**Proposal for:
Supplement 10 to the 07 Series of Amendments,
Supplement 02 to the 08 Series of Amendments and
Supplement 03 to the 09 Series of Amendments
of UN Regulation No. 14 (Safety-belt anchorages)**

This proposal is based on informal document GRSP-74-19 and the corresponding document GRSP/2023/28 and further amends the proposal originally introduced by OICA. Amendments to the text of UN Regulation 14 are indicated in bold or strike-through. Amendments to the text of GRSP/2023/28 are indicated in blue (according to GRSP-74-19).

During the last sessions of GRSP several CPs raised concerns and it was concluded to conduct a Workshop on this issue. The Workshop was held on 25th to 26th April at BAST and experts of Germany, the Netherlands, Sweden, Austria, OICA and CLEPA contributed. Further modifications to GRSP-74-19 are indicated in green.

[Insert new Annex 1, paragraph 9, to read:

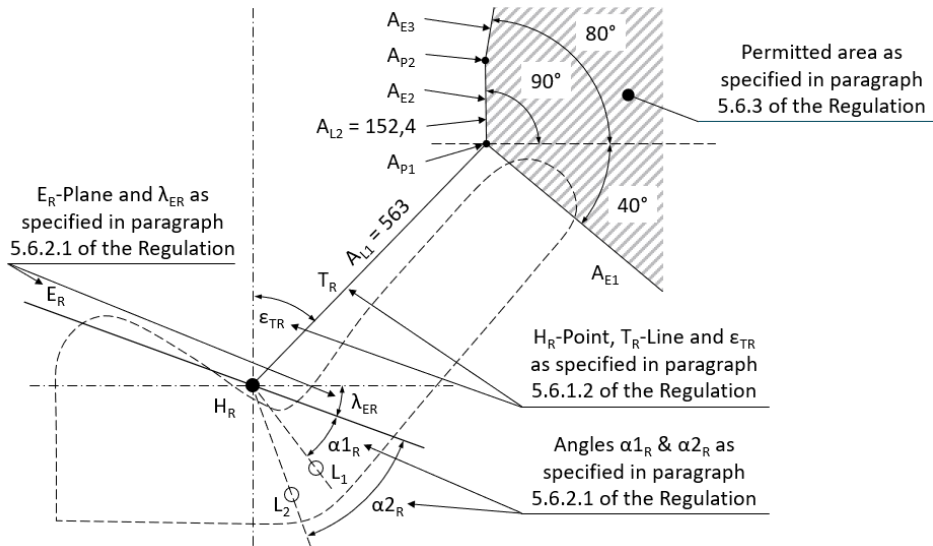
9. Usage of alternative anchorage positions (yes/no):

“Figure 4

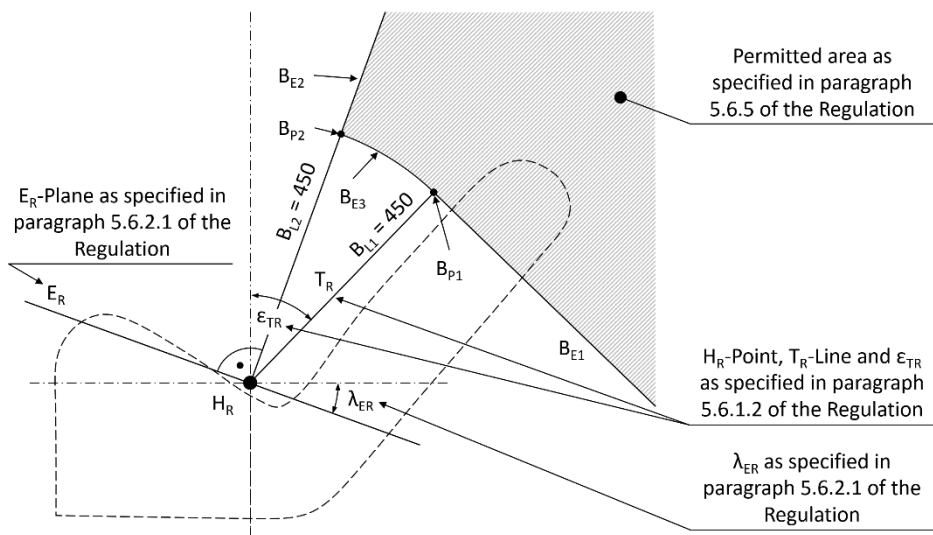
Based on the H_R -point, determine the permissible area shown in Figure 4 of Annex 3 to this Regulation for the effective upper belt anchorage point(s) during the test with the following segment sections and planes:

- B_{L1}** A segment of the torso line T_R measured **along the torso line T_R** in an upward direction from H_R and 450 mm long, ending with ~~the~~ point B_{P1}
- B_{L2}** A segment distance of 450 mm length, measured from the H_R-point perpendicular to the E_R-plane upwards, ending **with in the** point B_{P2}

A first plane B_{E1} is created backwards perpendicular to the torso line T_R and perpendicular to the longitudinal ~~center~~ **centre** plane of the seat at point B_{P1}.

A second plane B_{E2} is created upwards perpendicular to the E_R-plane and perpendicular to the longitudinal ~~center~~ **centre** plane of the seat at point B_{P2}.

A shell surface B_{E3} is created with a radius of 450 mm in the H_R-point between the points B_{P1} and B_{P2} perpendicular to the longitudinal ~~center~~ **centre** plane of the seat.

The effective upper belt anchorage point(s) shall not move below or in front of the planes B_{E1} and B_{E2} as well as shell surface B_{E3} during the test. “

Permitted area of location for upper effective belt anchorages according to paragraph 5.6.5 of this Regulation for extended use positions other use positions than normal ones

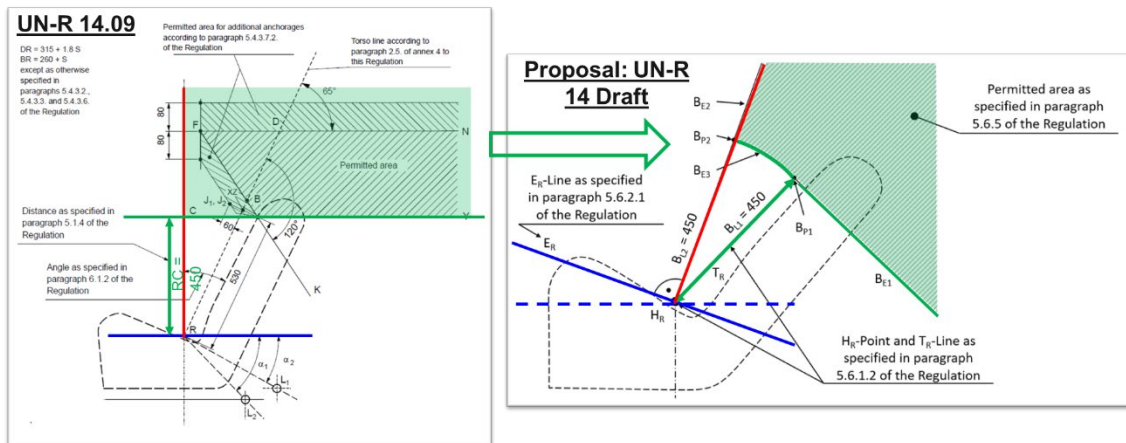
For the permitted area before the test the upper area is based on FMVSS 210 as this would enable sufficient mounting positions even when the seatback has a higher inclination.

For the permitted area during and after the test, a new area must be defined for the upper belt anchorages as otherwise the current provisions regarding the CY-line can very likely not be fulfilled. The idea is to create a permitted area, whose lower boundary is limited to a distance of min. 450 mm around the HR point.
